Virgil C. Summer Nuclear Station (VCSNS) Units 2 and 3
Combined License Nos. NPF-93 and NPF-94
Docket Nos. 52-027 & 52-028

Subject: VCSNS Units 2 & 3 Request for License Amendment and Exemption:
Main Control Room Emergency Habitability System (VES) Design
Changes (LAR 15-03)

Main Control Room Emergency Habitability System (VES) Design Changes

Proposed Changes to Licensing Basis Documents (LAR 15-03)

COL Appendix C Figure 2.2.5-1 and corresponding Plant-Specific Tier 1 Figure 2.2.5-1, Main Control Room Emergency Habitability System

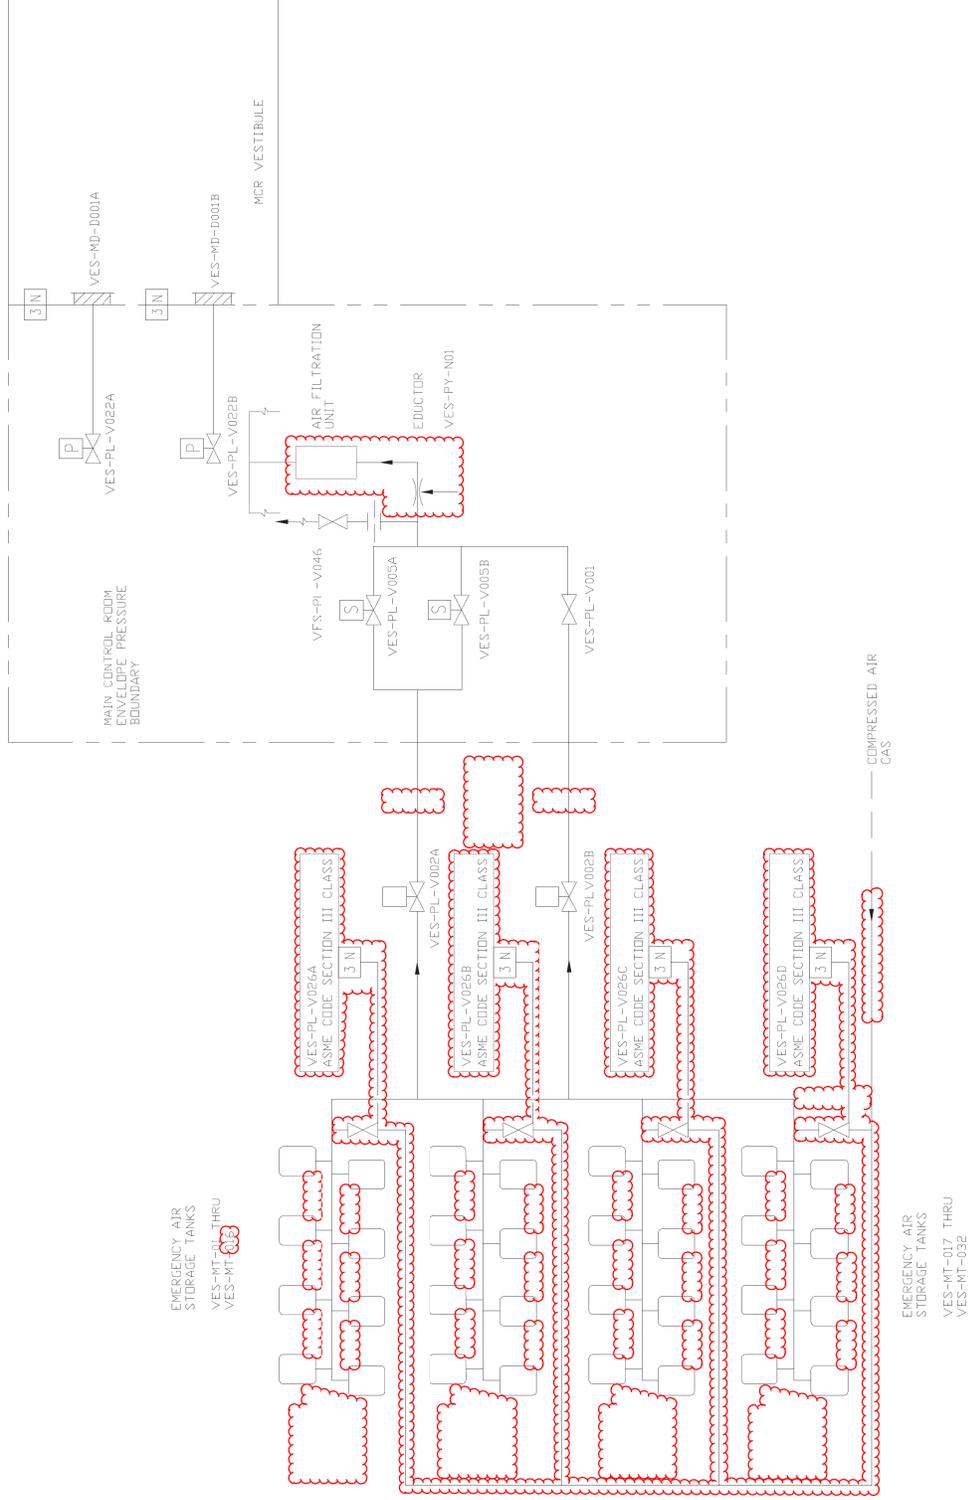
1. COL Appendix C Figure 2.2.5-1 is revised as follows:
 - a) The orientation of the MCR air filtration line eductor is changed so that the emergency air storage tanks are connected to the motive air inlet of the eductor and the MCR air inlet is connected to the suction tap of the eductor;
 - b) Add an air bank fill / vent header with an air tank fill / vent isolation valve at each of the four air banks;

c) Move the ASME Code classification transition (Class 3 to nonsafety-related) to immediately upstream of the proposed air tank fill / vent isolation valves;

d) Remove the refill line isolation valve (refill line isolation valve VES-PL-V038);

e) Remove the flow control orifices (flow restricting orifices) downstream of the pressure regulating valves VES-PL-V002A and VES-PL-V002B;

f) Change the designation of the emergency air storage tanks in the upper banks from VES-MT-01 thru VES-MT-18 to VES-MT-01 thru VES-MT-16; and

g) Remove the ASME Code classification transition at the emergency air storage tanks at eight locations.

UFSAR Figure 6.4-2 (Sheet 2 of 2) Simplified Main Control Room Habitability System Piping and Instrumentation Diagram (REF) VES 002

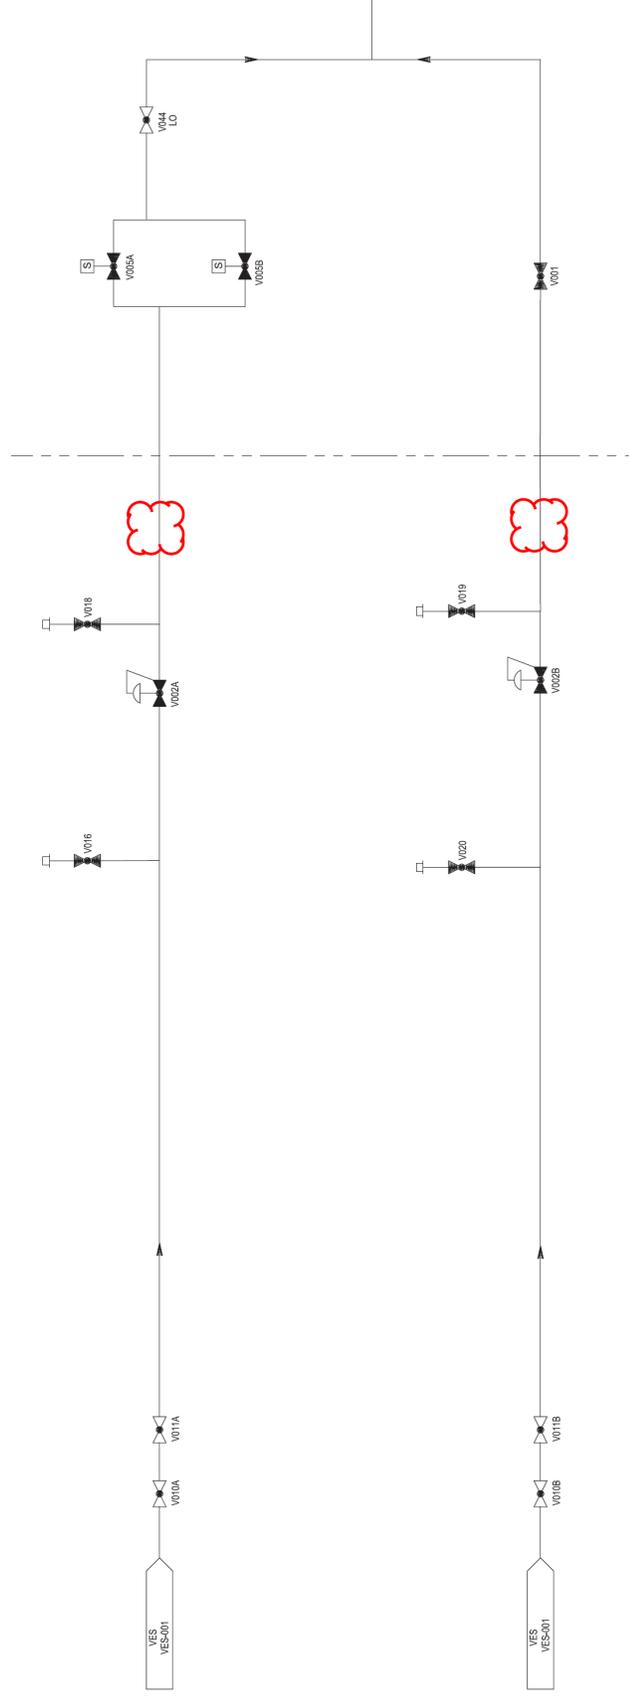
3. UFSAR Figure 6.4-2 (Sheet 2) is revised as follows:

a) The orientation of the MCR air filtration line eductor is changed so that the emergency air storage tanks are connected to the motive air inlet of the eductor and the MCR air inlet is connected to the suction tap of the eductor; and

b) Remove the flow control orifices downstream of the pressure regulating valves VES-PL-V002A and VES-PL-V002B.
